FAIR SOLAR PROGRAM

Opportunities and Conditions for the
Fair and Sustainable Development of
Distributed Photovoltaic Electricity
Generation on Efaté Island

Port Vila, Vanuatu | May 9th 2014

This document is UNELCO's official submission in response to:
URA's Notice of Request for Comments and Public Consultation, case U-0002-14, titled: "Investigating and Implementing feed-in tariffs and net-metering scheme for renewable energy in Port Vila" (April 2014)

Table 7: Payback calculation for Other Low Voltage Customer using Net Metering with Access Fee

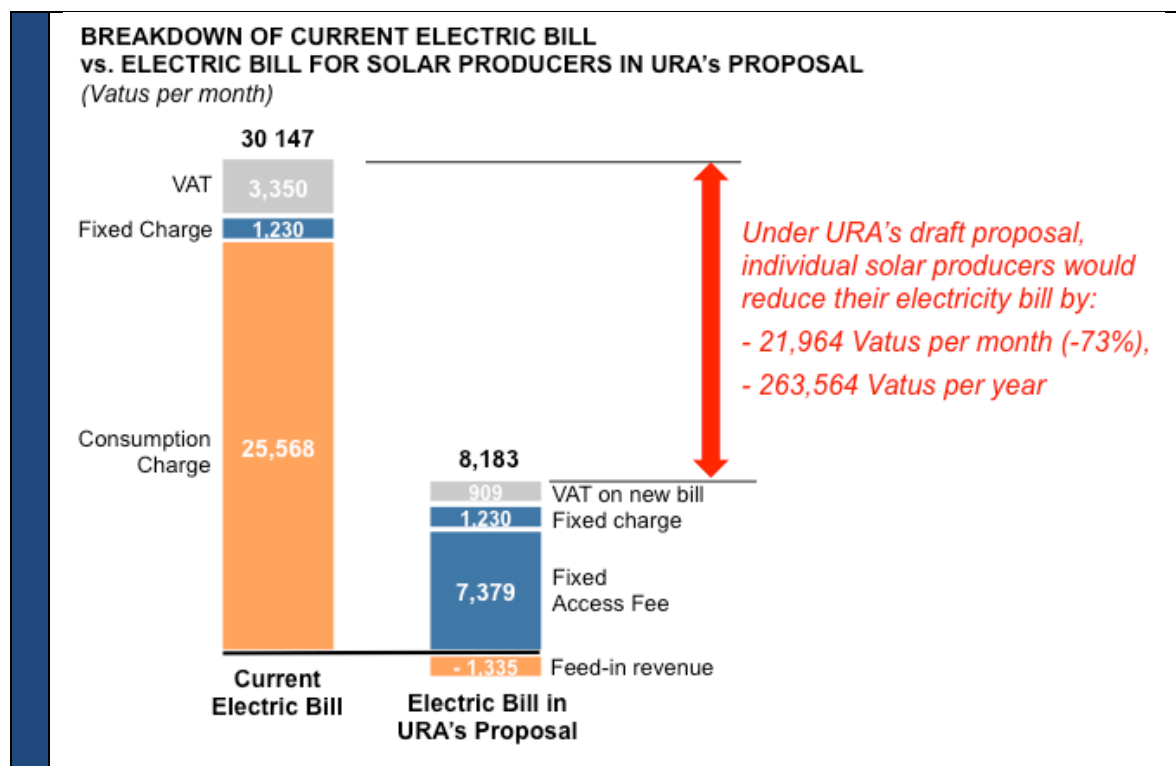
URA’s analysis is accurate before tax but omits the consequential VAT effect. Solar customers would avoid the majority of their previous electric bill’s VAT, which would increase the net benefit to the customer to 21,964 Vatus per month, rather than 19,523 Vatus per month.

This discount, totaling 263,564 Vatus/year, would represent a 73% decrease in from their previous network electric bill. Taking into account the avoided VAT, the domestic solar customer payback period would therefore be 6.3 years, better still than the 7.1 years as presented by URA.

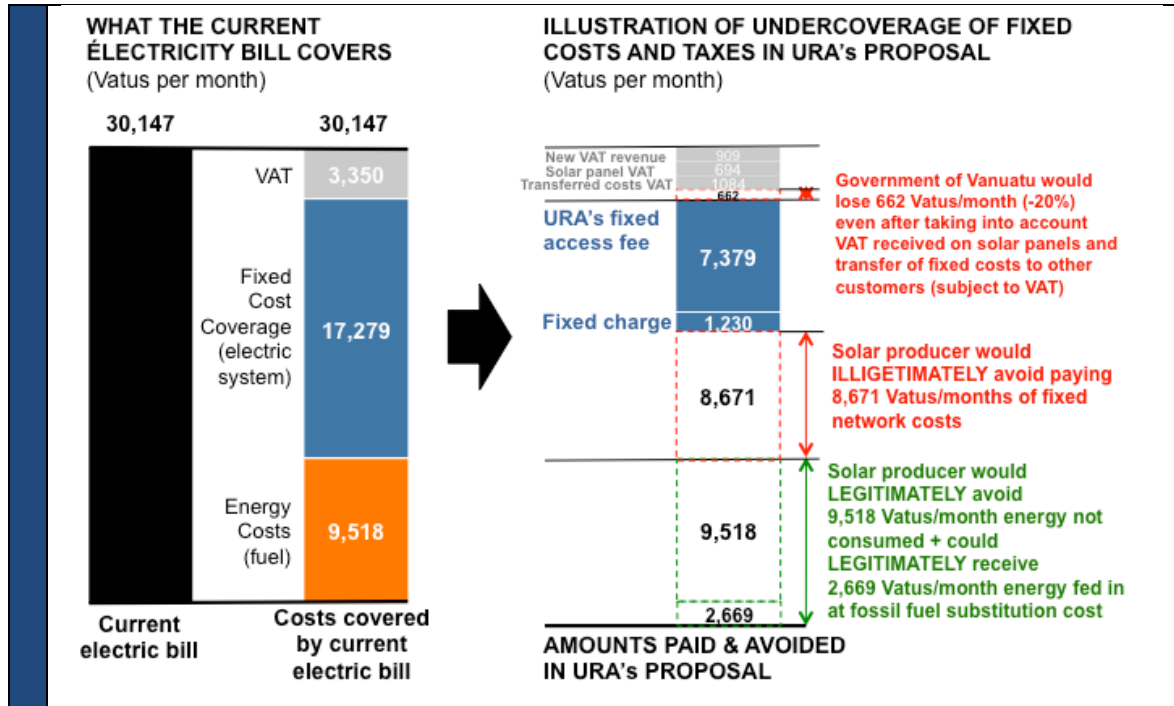
This subsidy is neither financed by URA nor by the Government, it is a cross-subsidy between clients. This means that clients without solar panels would not only not receive the legitimate benefits of PV solar but they would also start paying more in order to finance a subsidy received by the PV solar customers.

As shown in the graphic above, the independent solar generators should legitimately save the fossil fuel cost equivalent of their solar generation (12,147 Vatus per month⁷) but they also illegitimately 9,333 Vatus per month that they should be paying to cover the fixed costs of the electric system and Government VAT (8,671 Vatus of fixed system costs and 662 Vatus of VAT).

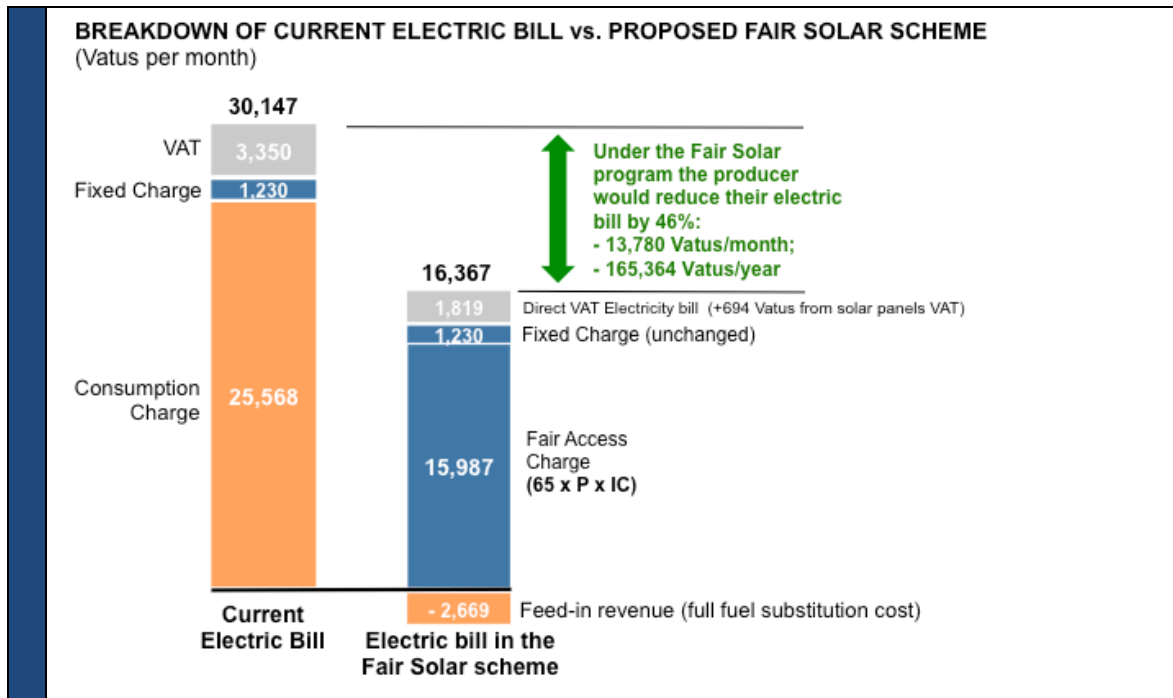
= Per year for all domestic solar customers in trial (x50): 4,951,800 Vatus

= Over the lifetime of these customers solar panels (x 25 years): **123,795,000 Vatus**

To avoid the cross subsidy illustrated prior, that is not grounded in an economic requirement or have a defensible social fairness basis, URA should recalibrate their proposed "access fee". The fact that the utility could procure fed in electricity at 50% of fuel substitution cost is greatly insufficient to compensate the under-collection of fixed costs (cf. previous graphic)

This level of access fee would ensure neutrality for all the other electric customers and provide a fair and true price signal to all customers considering distributed generation; customers considering distributed generation would reap 100% of current and future price benefits of solar production versus the evolution of fossil fuel production but would not create a financial burden for other customers.

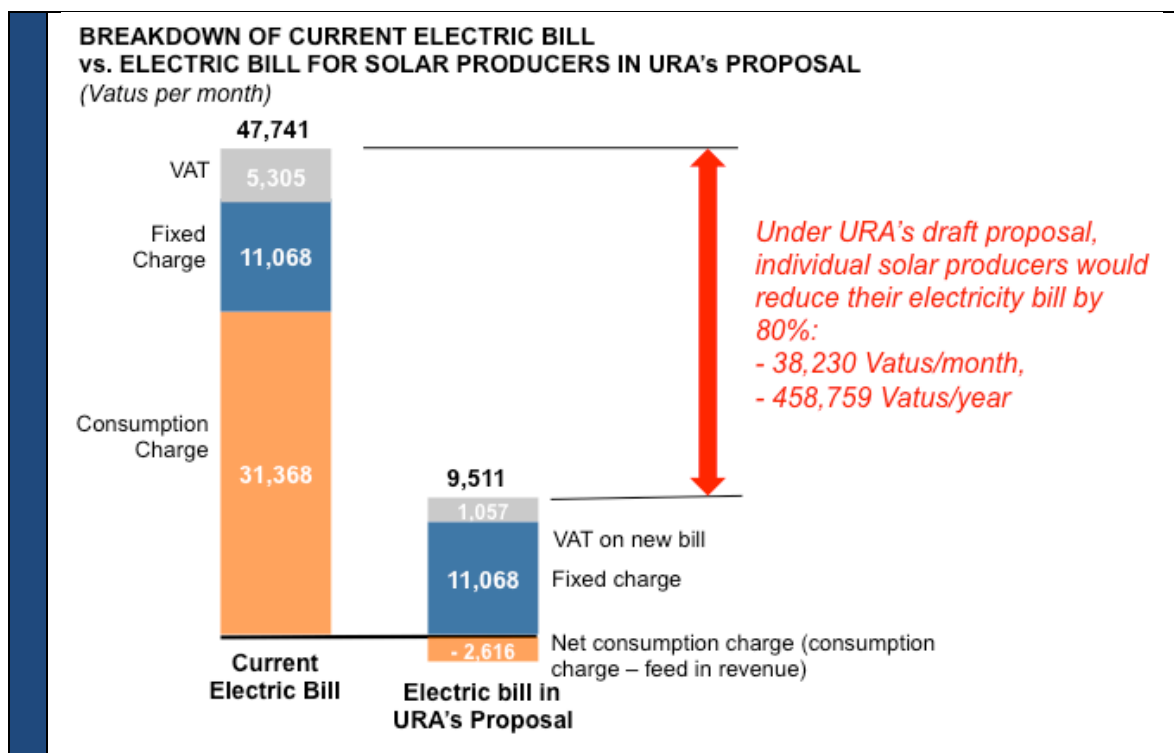
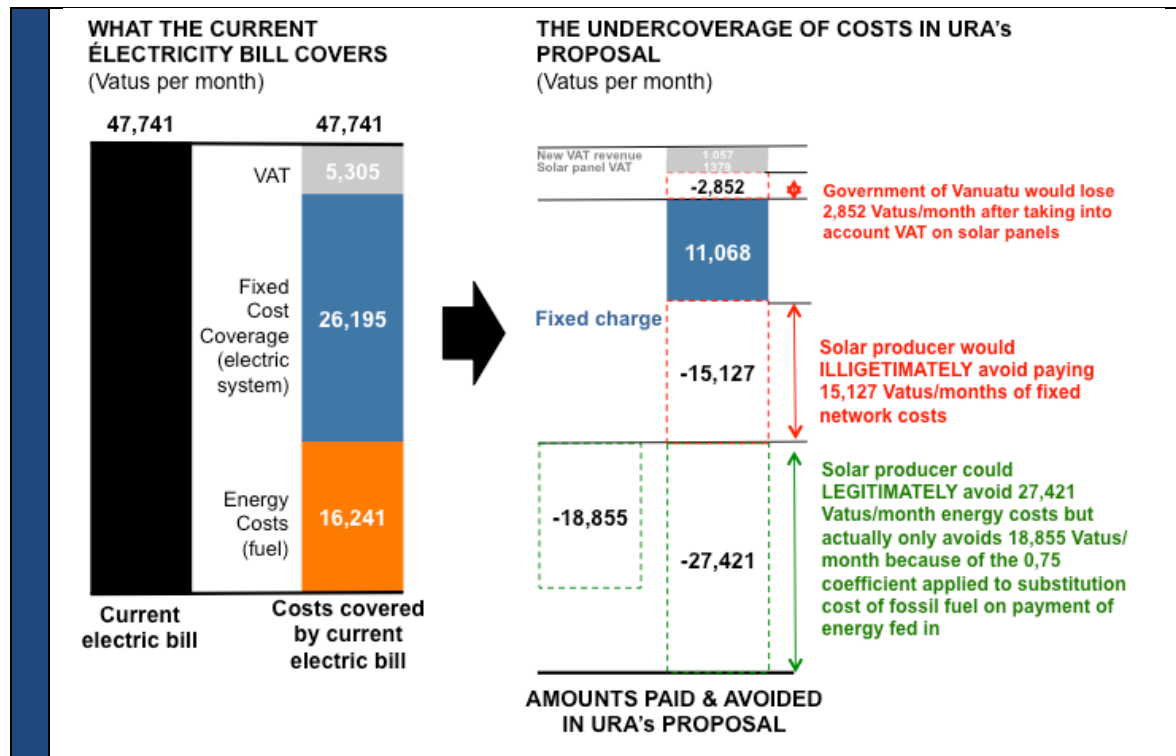
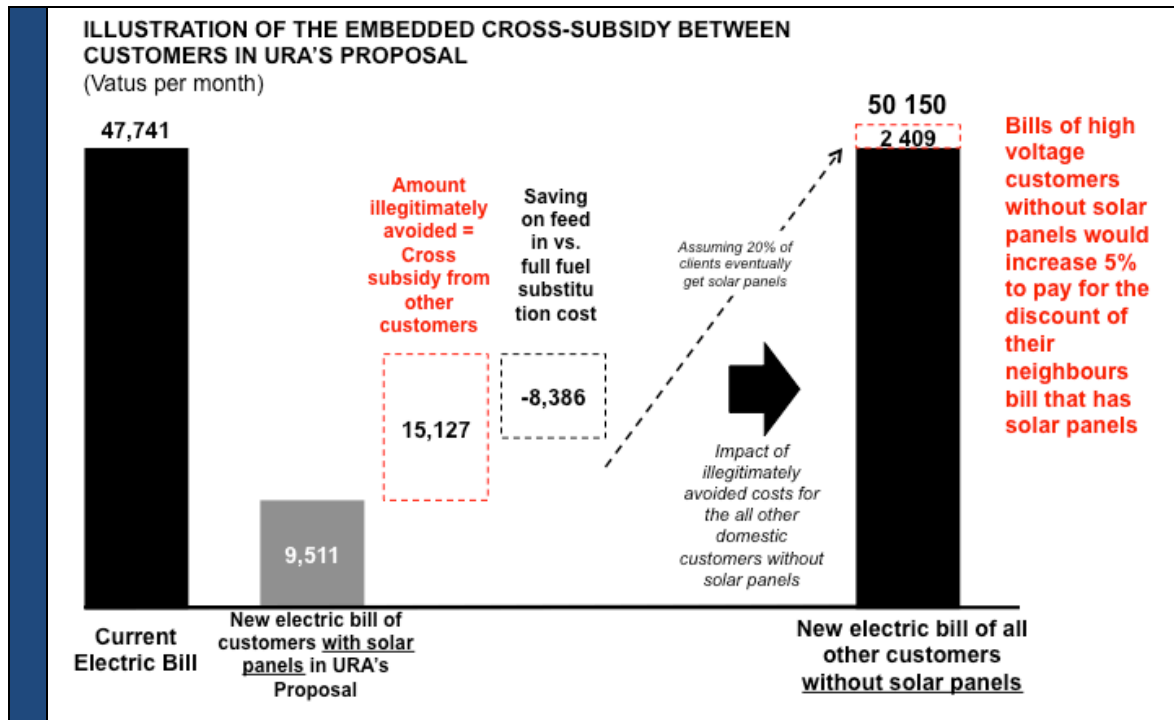
URA’s analysis is accurate before tax but omits the consequential VAT effect. Solar customers would avoid the majority of their previous electric bill’s VAT, which would increase the net benefit to the customer to 38,230 Vatus per month, rather than 33,997 Vatus per month estimated by URA.

This discount, totaling 458,759 Vatus per year, would represent a 80% decrease in from their previous network electric bill. Taking into account the avoided VAT, the domestic solar customer payback period would therefore be 7.3 years, better still than the 8.2 years presented by URA.

As with the domestic customers, the subsidy is neither financed by URA nor by the Government, it is also a cross-subsidy between clients: customers without solar panels would pay more for electricity so customers with solar panels could pay less.

- Would legitimately save the fossil fuel cost equivalent of their solar generation 18,855 Vatus
- but they would also, additionally, illegitimately save approximately 17,000 Vatus per month that they should be paying to cover the fixed costs of the electric system (15,127 Vatus of fixed costs and 2,852 Vatus of VAT).

Unelco recommends that URA add a Fair Access charge equal to $20 \times P \times \text{Installed solar capacity}$. The Fair Access charge would cancel out the cross subsidy between clients, making the system neutral for all the other clients without solar panels.

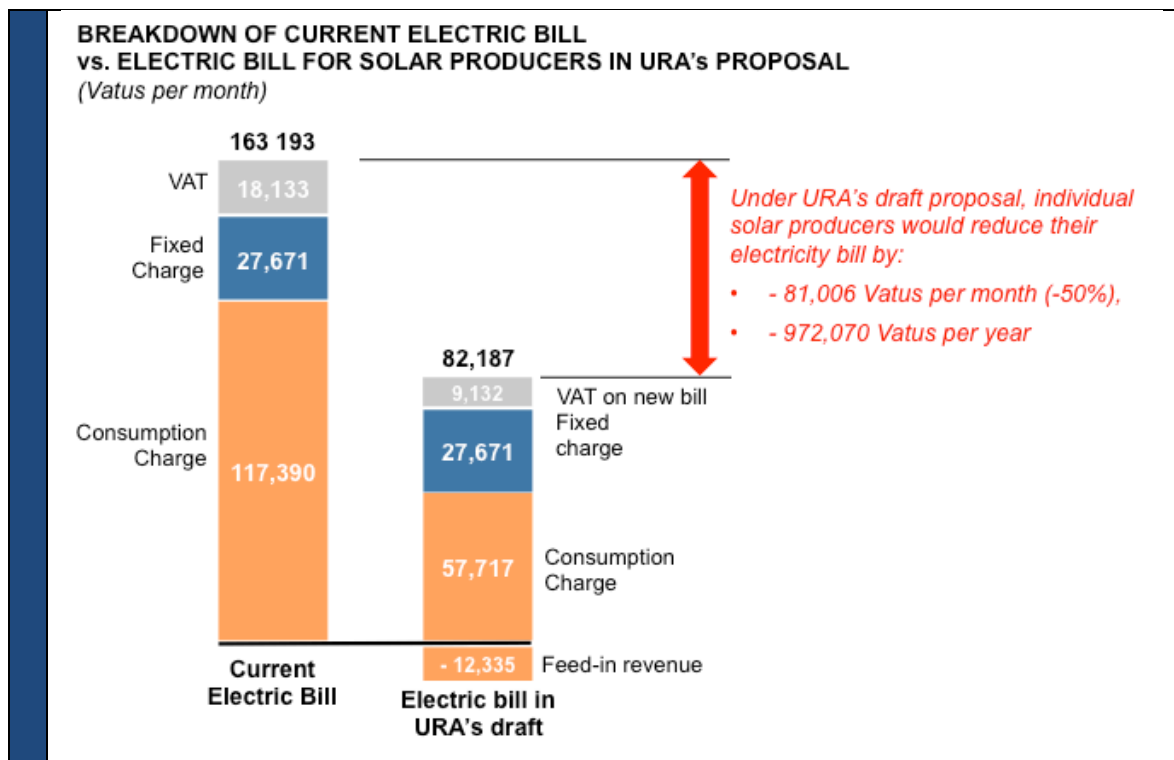
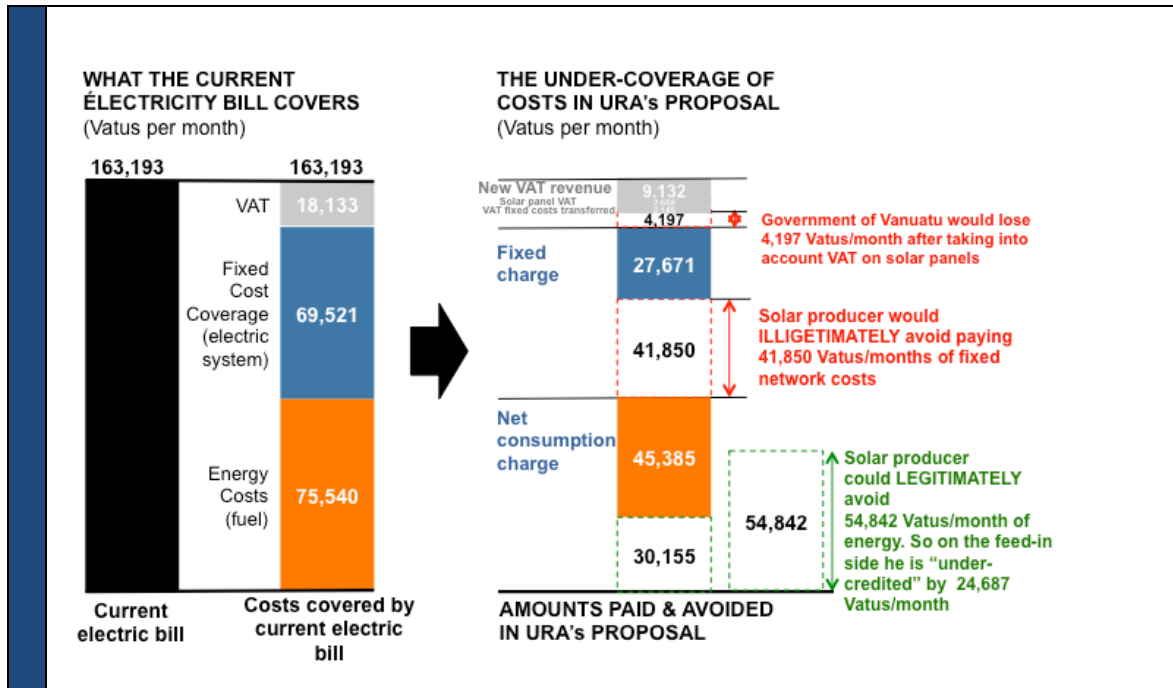
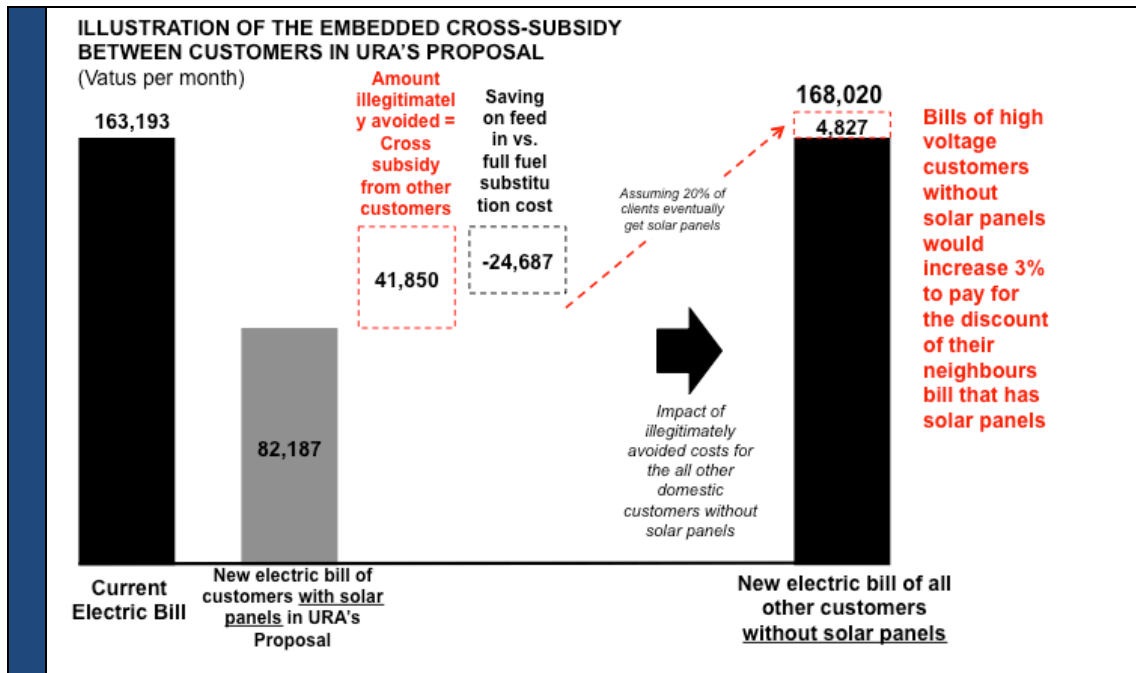
As for the previous examples, URA’s analysis is accurate before tax but omits the consequential VAT effect. Solar customers would avoid the majority of their previous electric bill’s VAT, which would increase the net benefit to the customer to 81,006 Vatus per month, rather than 71,997 Vatus per month presented by URA.

This discount, totaling 972,070 Vatus per year, would represent a 50% decrease in from their previous network electric bill. Taking into account the avoided VAT, the domestic solar customer payback period would therefore be 6.6 years, better still than the 7.4 years presented by URA in their analysis.

As with the other PV generators examples, this would be a subsidy from customers without solar panels, who would pay more for electricity, towards customers with solar panels, so they could pay even less.

- Could legitimately save the fossil fuel cost equivalent of their solar generation (54,842 Vatus per month at fossil fuel substitution value but in reality only avoids 30,155 Vatus per month)
- but they would also, additionally, illegitimately save approximately 46,000 Vatus per month that they should be paying to cover the fixed costs of the electric system and VAT (41,850 Vatus of fixed costs and 4,197 Vatus of VAT).

Unelco recommends that URA add a Fair Access charge equal to $20 \times P \times \text{Installed solar capacity}$. The Fair Access charge would cancel out the cross subsidy between clients, making the system neutral for all the other clients without solar panels.
